LIVERPOOL CITY COUNCIL

JOINT REGIONAL PLANNING PANEL - ASSESSMENT REPORT

JRPP Reference Number	2012SYW096
Development Application Number	DA-410/2010/A
Proposed Development:	Modification to Development Consent DA-410/2010 pursuant to Section 96(2) of the Environmental Planning & Assessment Act 1979. The modification seeks to: <ol style="list-style-type: none">1. Amend the car parking design and relocate the car parking area.2. Extend the hours of operation to permit 24 hour operation of the facility.3. Change the layout of the stockpile bins.4. Increase the platform area of the processing area for recovered aggregate.
Address	Lots 4 & 5 DP 24315, Nos 65 – 75 Yarrawa Street (and Illaroo Road) Prestons
Applicant:	Kypter Pty Ltd
Land Owner:	Sydney Invitation Futurity Pty Ltd & Rentail Pty Ltd

Figure 2. Superseded site plan proposal

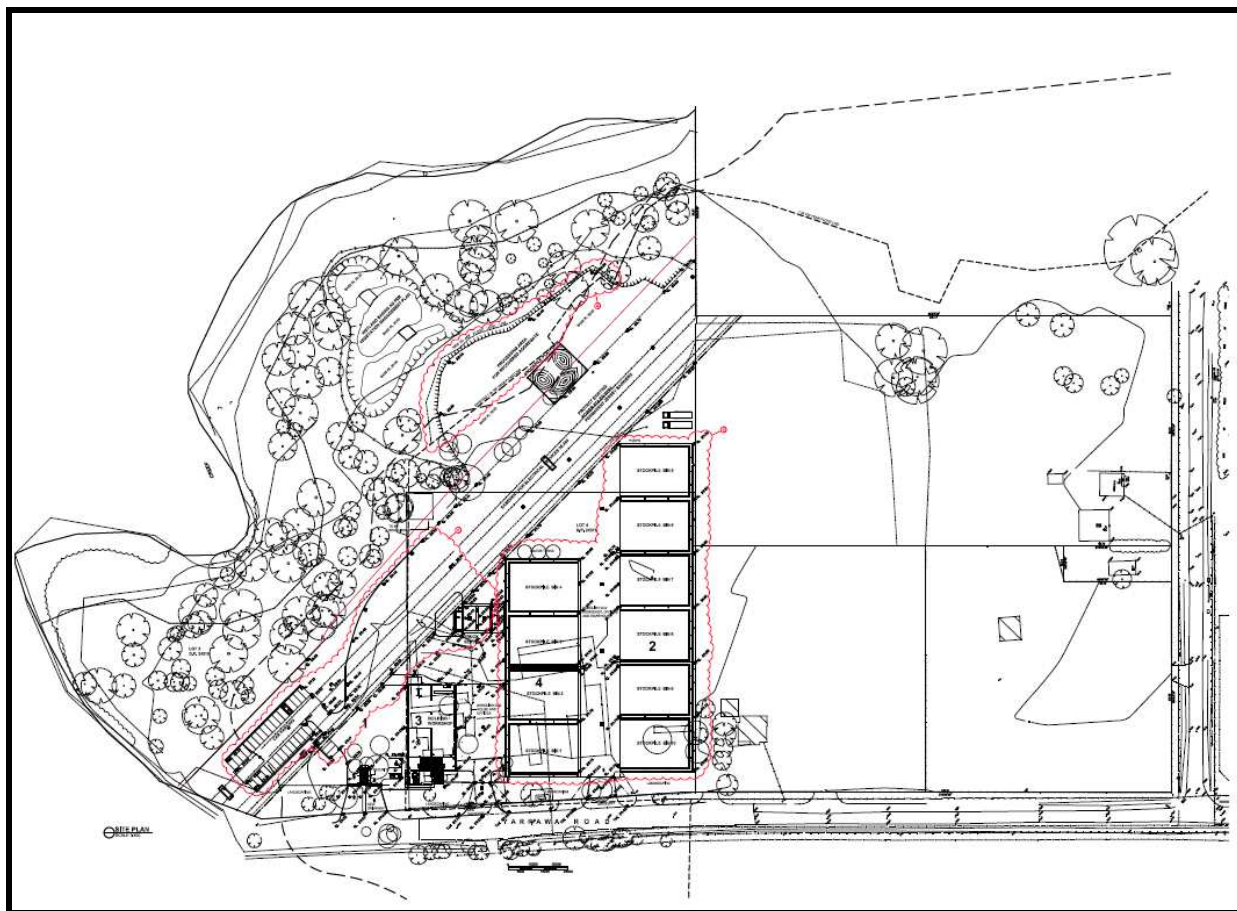
The approved 39 space car parking area and associated driveway are located in the 30.48 metre wide electrical easement traversing the site. An application to carry out work within the easement was made to Endeavour Energy by the applicant. This was refused on the grounds that there was insufficient clearance under the electrical conductors.

To overcome this problem, the applicant proposed moving the car park along the electricity easement from a mid-span location between two transmission line supports to a location closer to one support. This location was better able to obtain adequate conductor safety clearance and still meet Council's minimum flood level requirements. The area is already cleared and thus, the altered car parking location would have minimal environmental impact.

However, a significant portion of this cleared area is zoned E2 Environmental Conservation. This zoning does not permit the use of a resource recovery facility. Thus, a significant portion of the car park would now encroach on E2 zoned land and was not permitted. *Clause 5.3 Development near Zone Boundaries* of LLEP 2008 does not apply to E2 zoned land and could not be utilised to achieve flexibility. Thus, refusal of this aspect of the proposal was previously recommended.

Figure 4. Current proposed site plan

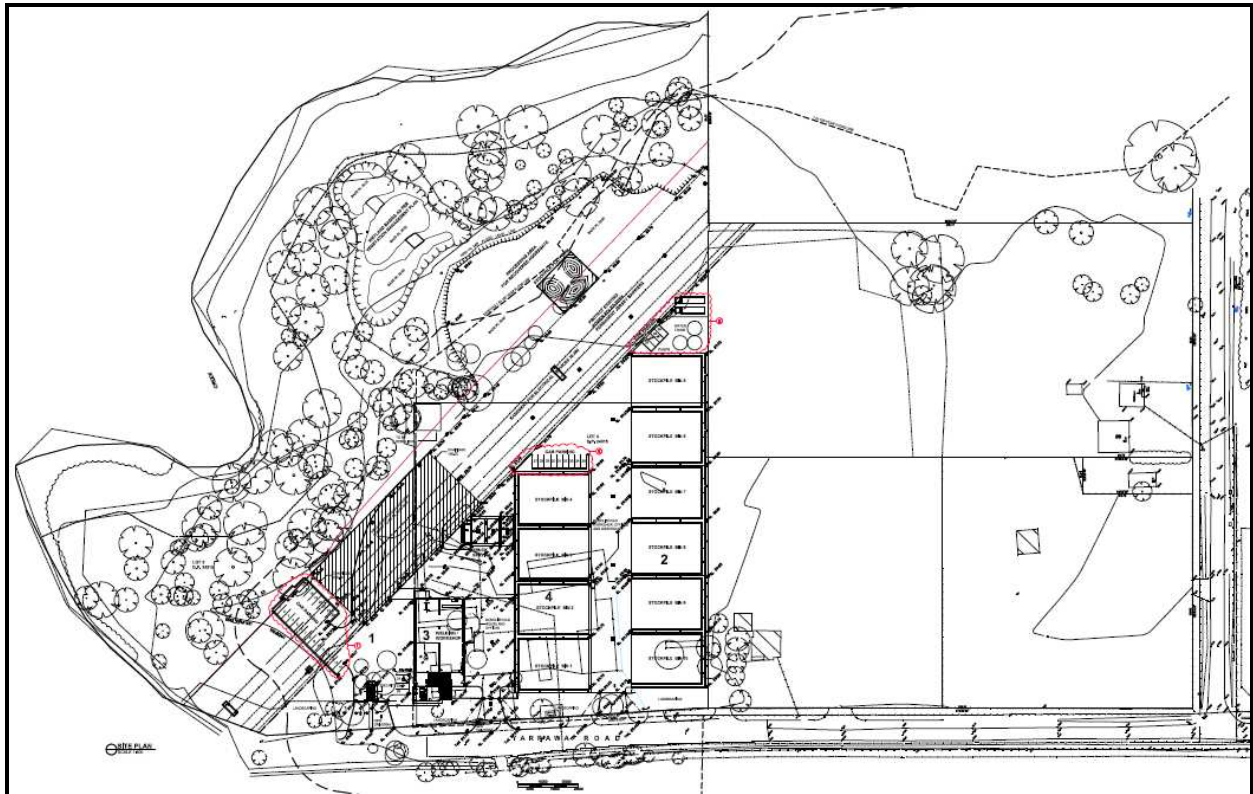
The applicant has submitted a modified car parking layout that is located clear of the land zoned for Environmental Conservation purposes and is considered to achieve satisfactory clearances regarding flood levels and overhead electrical conductors.

This latest car park design reorientates the parking in the electrical easement to allow for 23 spaces. The balance of 16 spaces has been moved to the northern end of the stockpile bins. These 16 spaces are out the electricity easement, above the flood level and do not obstruct truck and loader movement areas. As these spaces will be utilised by staff and not site visitors the traversing of areas utilised by heavy vehicles is not considered a significant issue.

This amended car park design has been referred to Endeavour Energy for comment however, a response has not been received from Endeavour Energy at the time of finalising this report. Comments are expected by the date of the panel meeting.

Endeavour Energy in commenting on the previous car park layouts advised inter alia that between chainages 150m and 220m that it was crucial that final surface levels do not exceed 28.5m AHD. The current design maintains this clearance by not locating any vehicles in this area. Thus 16 spaces are required to be located in a separate location outside the easement.

Approval of Part A is recommended subject to the requirements of Endeavour Energy.
